Staff Review of Proposed Subdivision Amendment

Re: Hideout Canyon Phase 1 – Lot 37 Amendment to Residential Subdivision

RE: Hideout Canyon Phase 1 - Lot 37 Plat Amendment Application Comments

**HIDEOUT CANYON PHASE 1, 2ND AMENDED
AMENDING LOT 37 OF
POD 9 RESIDENTIAL PLAT
A RESIDENTIAL DEVELOPMENT**

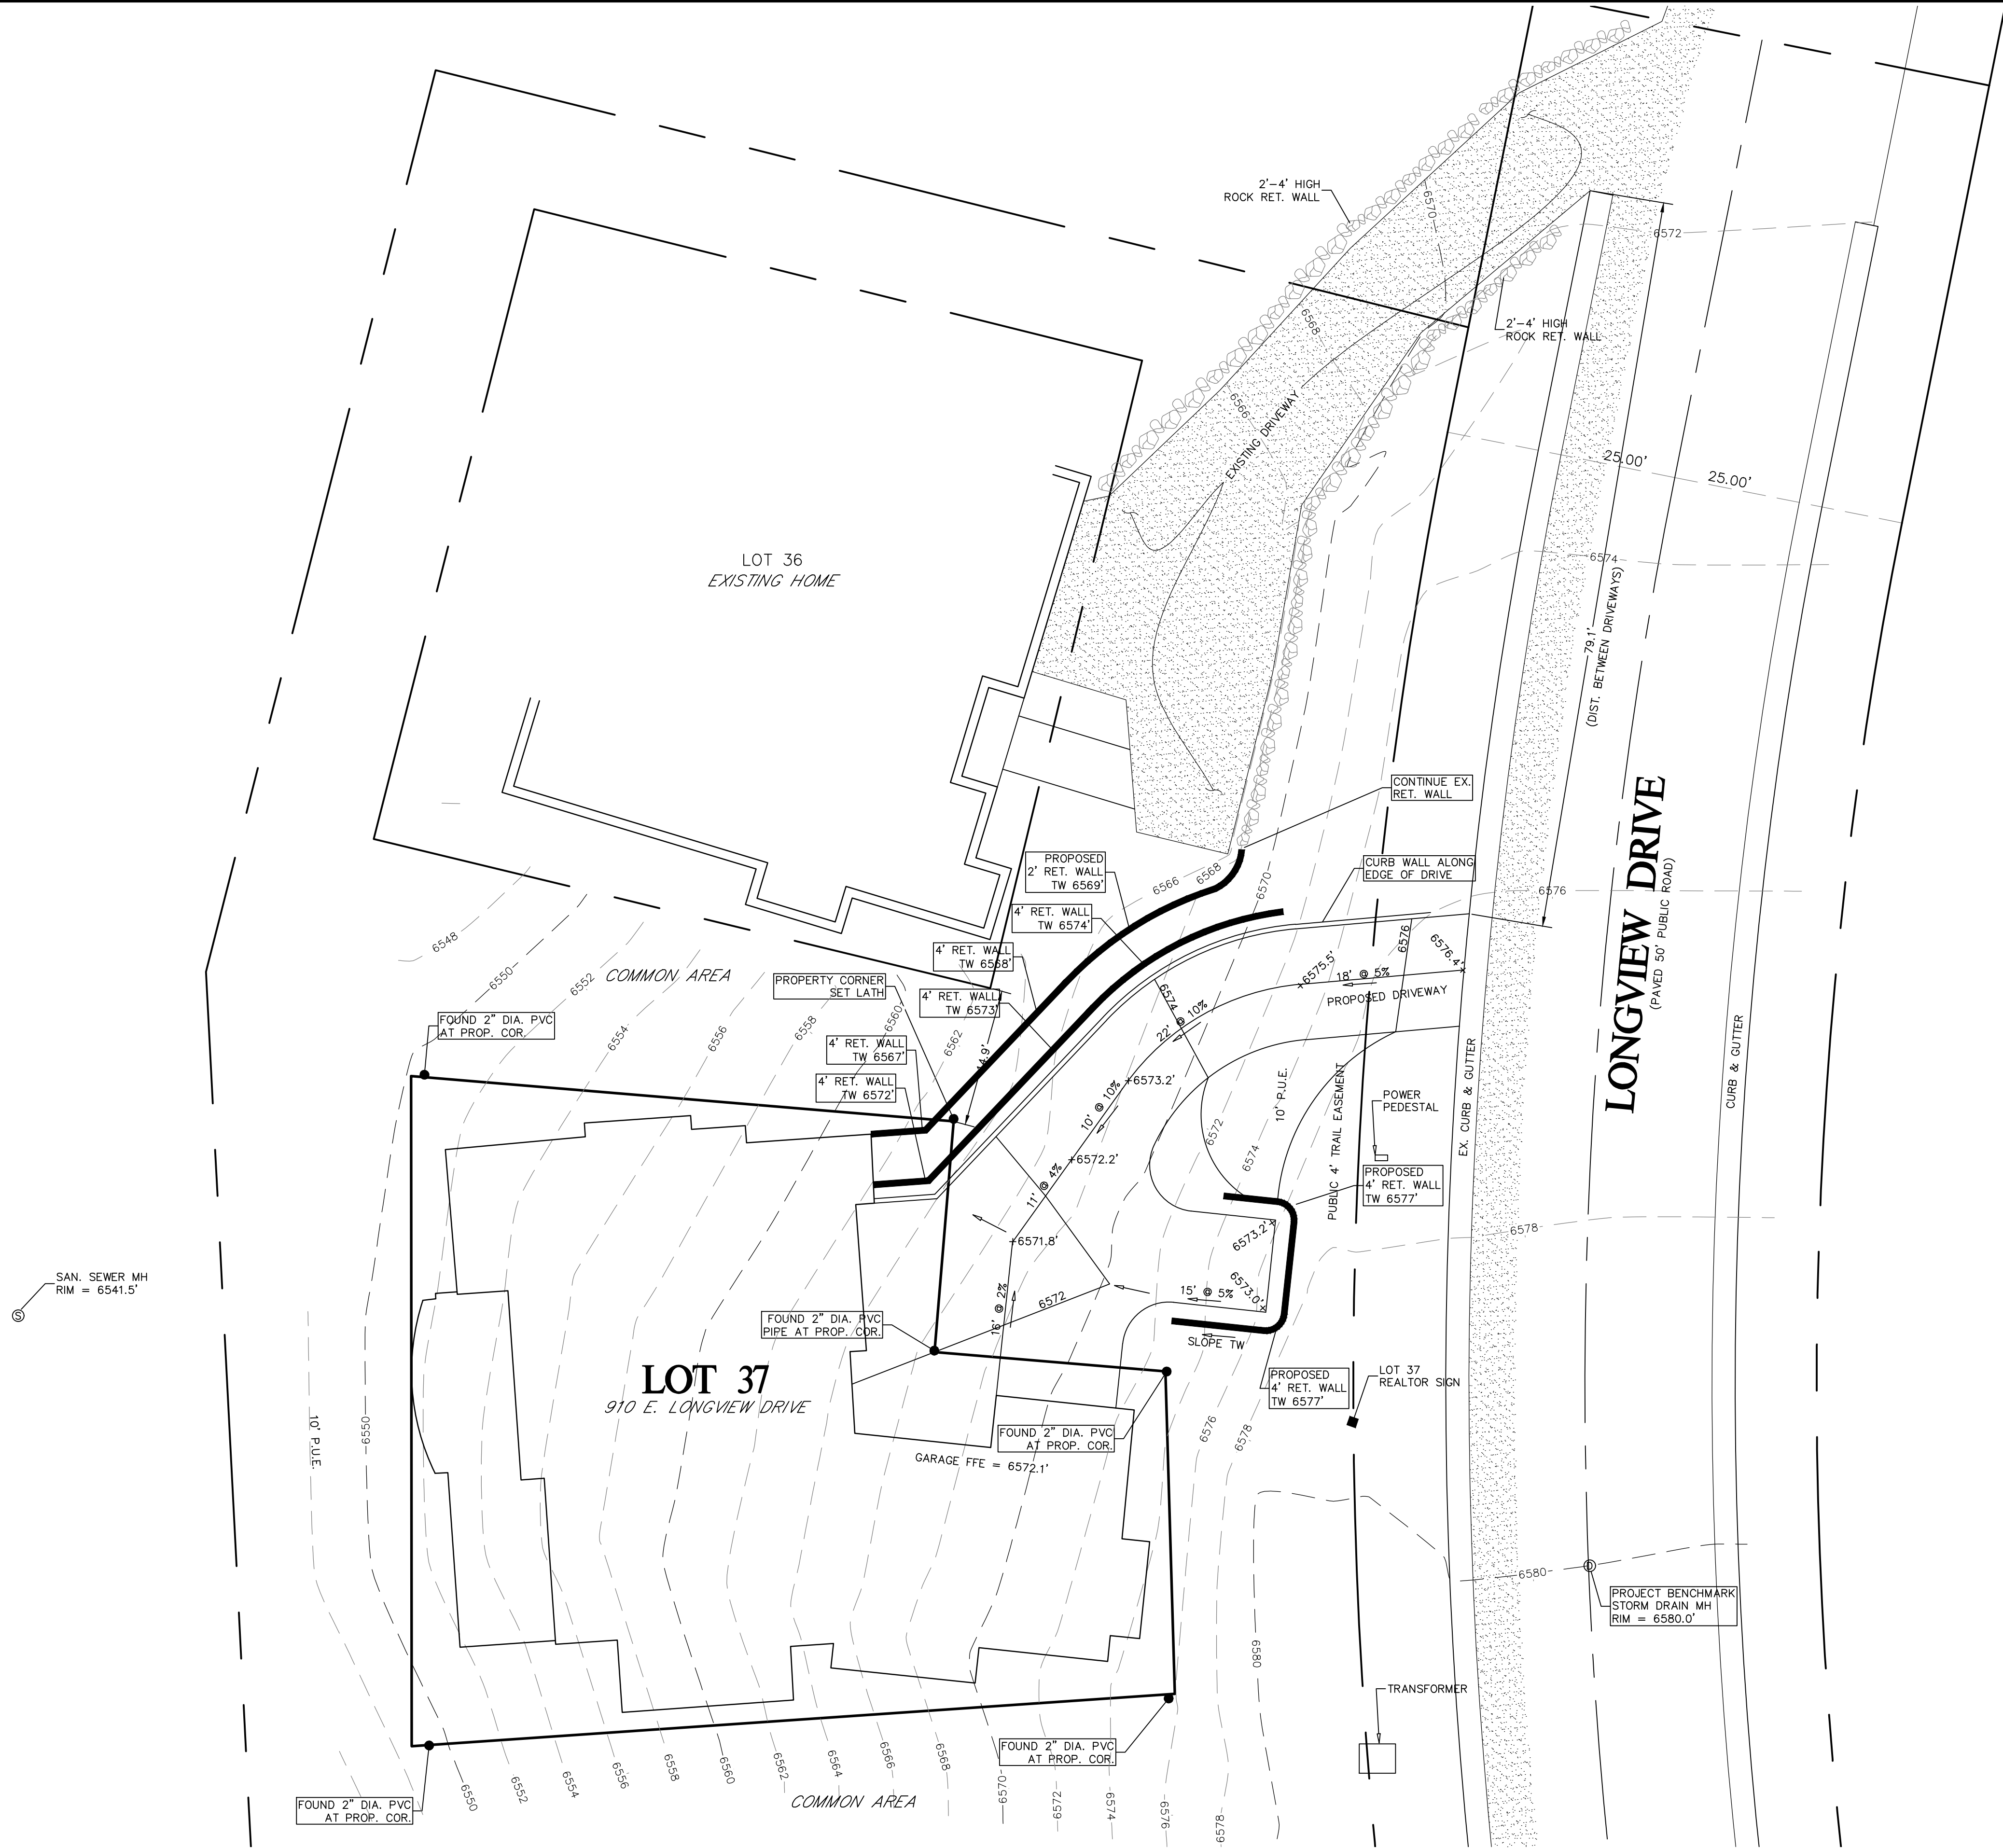
1. If the proposed driveway amendment is approved, will the two driveways be completely independent or will the proposed amendment simply result in additional pavement, stormwater runoff, and site disturbance? The two driveways should be completely separated (no physical connections). The plat should be revised to show space between the two driveway easements (a strip of 'common' land, not 'limited common' with cross hatching).

3. The back-out area proposed for Lot 37 is quite close to Longview Drive and should be removed.
4. The Applicant indicated the driveway to the north (north end of the existing shared driveway) is approximately 79'-0" from this proposed driveway connection to Longview Road. This should be confirmed at the meeting.

1. Although it is generally recommended that development not increase the number of driveway accesses on Longview Drive, it may make sense to eliminate a shared driveway. The Applicant shall clarify if the proposed end result is two separate driveways. Should they add an access to Longview Drive, we would like to see the shared driveway connection removed.
2. The driveway cannot exceed 14% slope. Proposed grading should be provided for the Planning Commission, Town Engineer and Town Planner to review at the meeting.
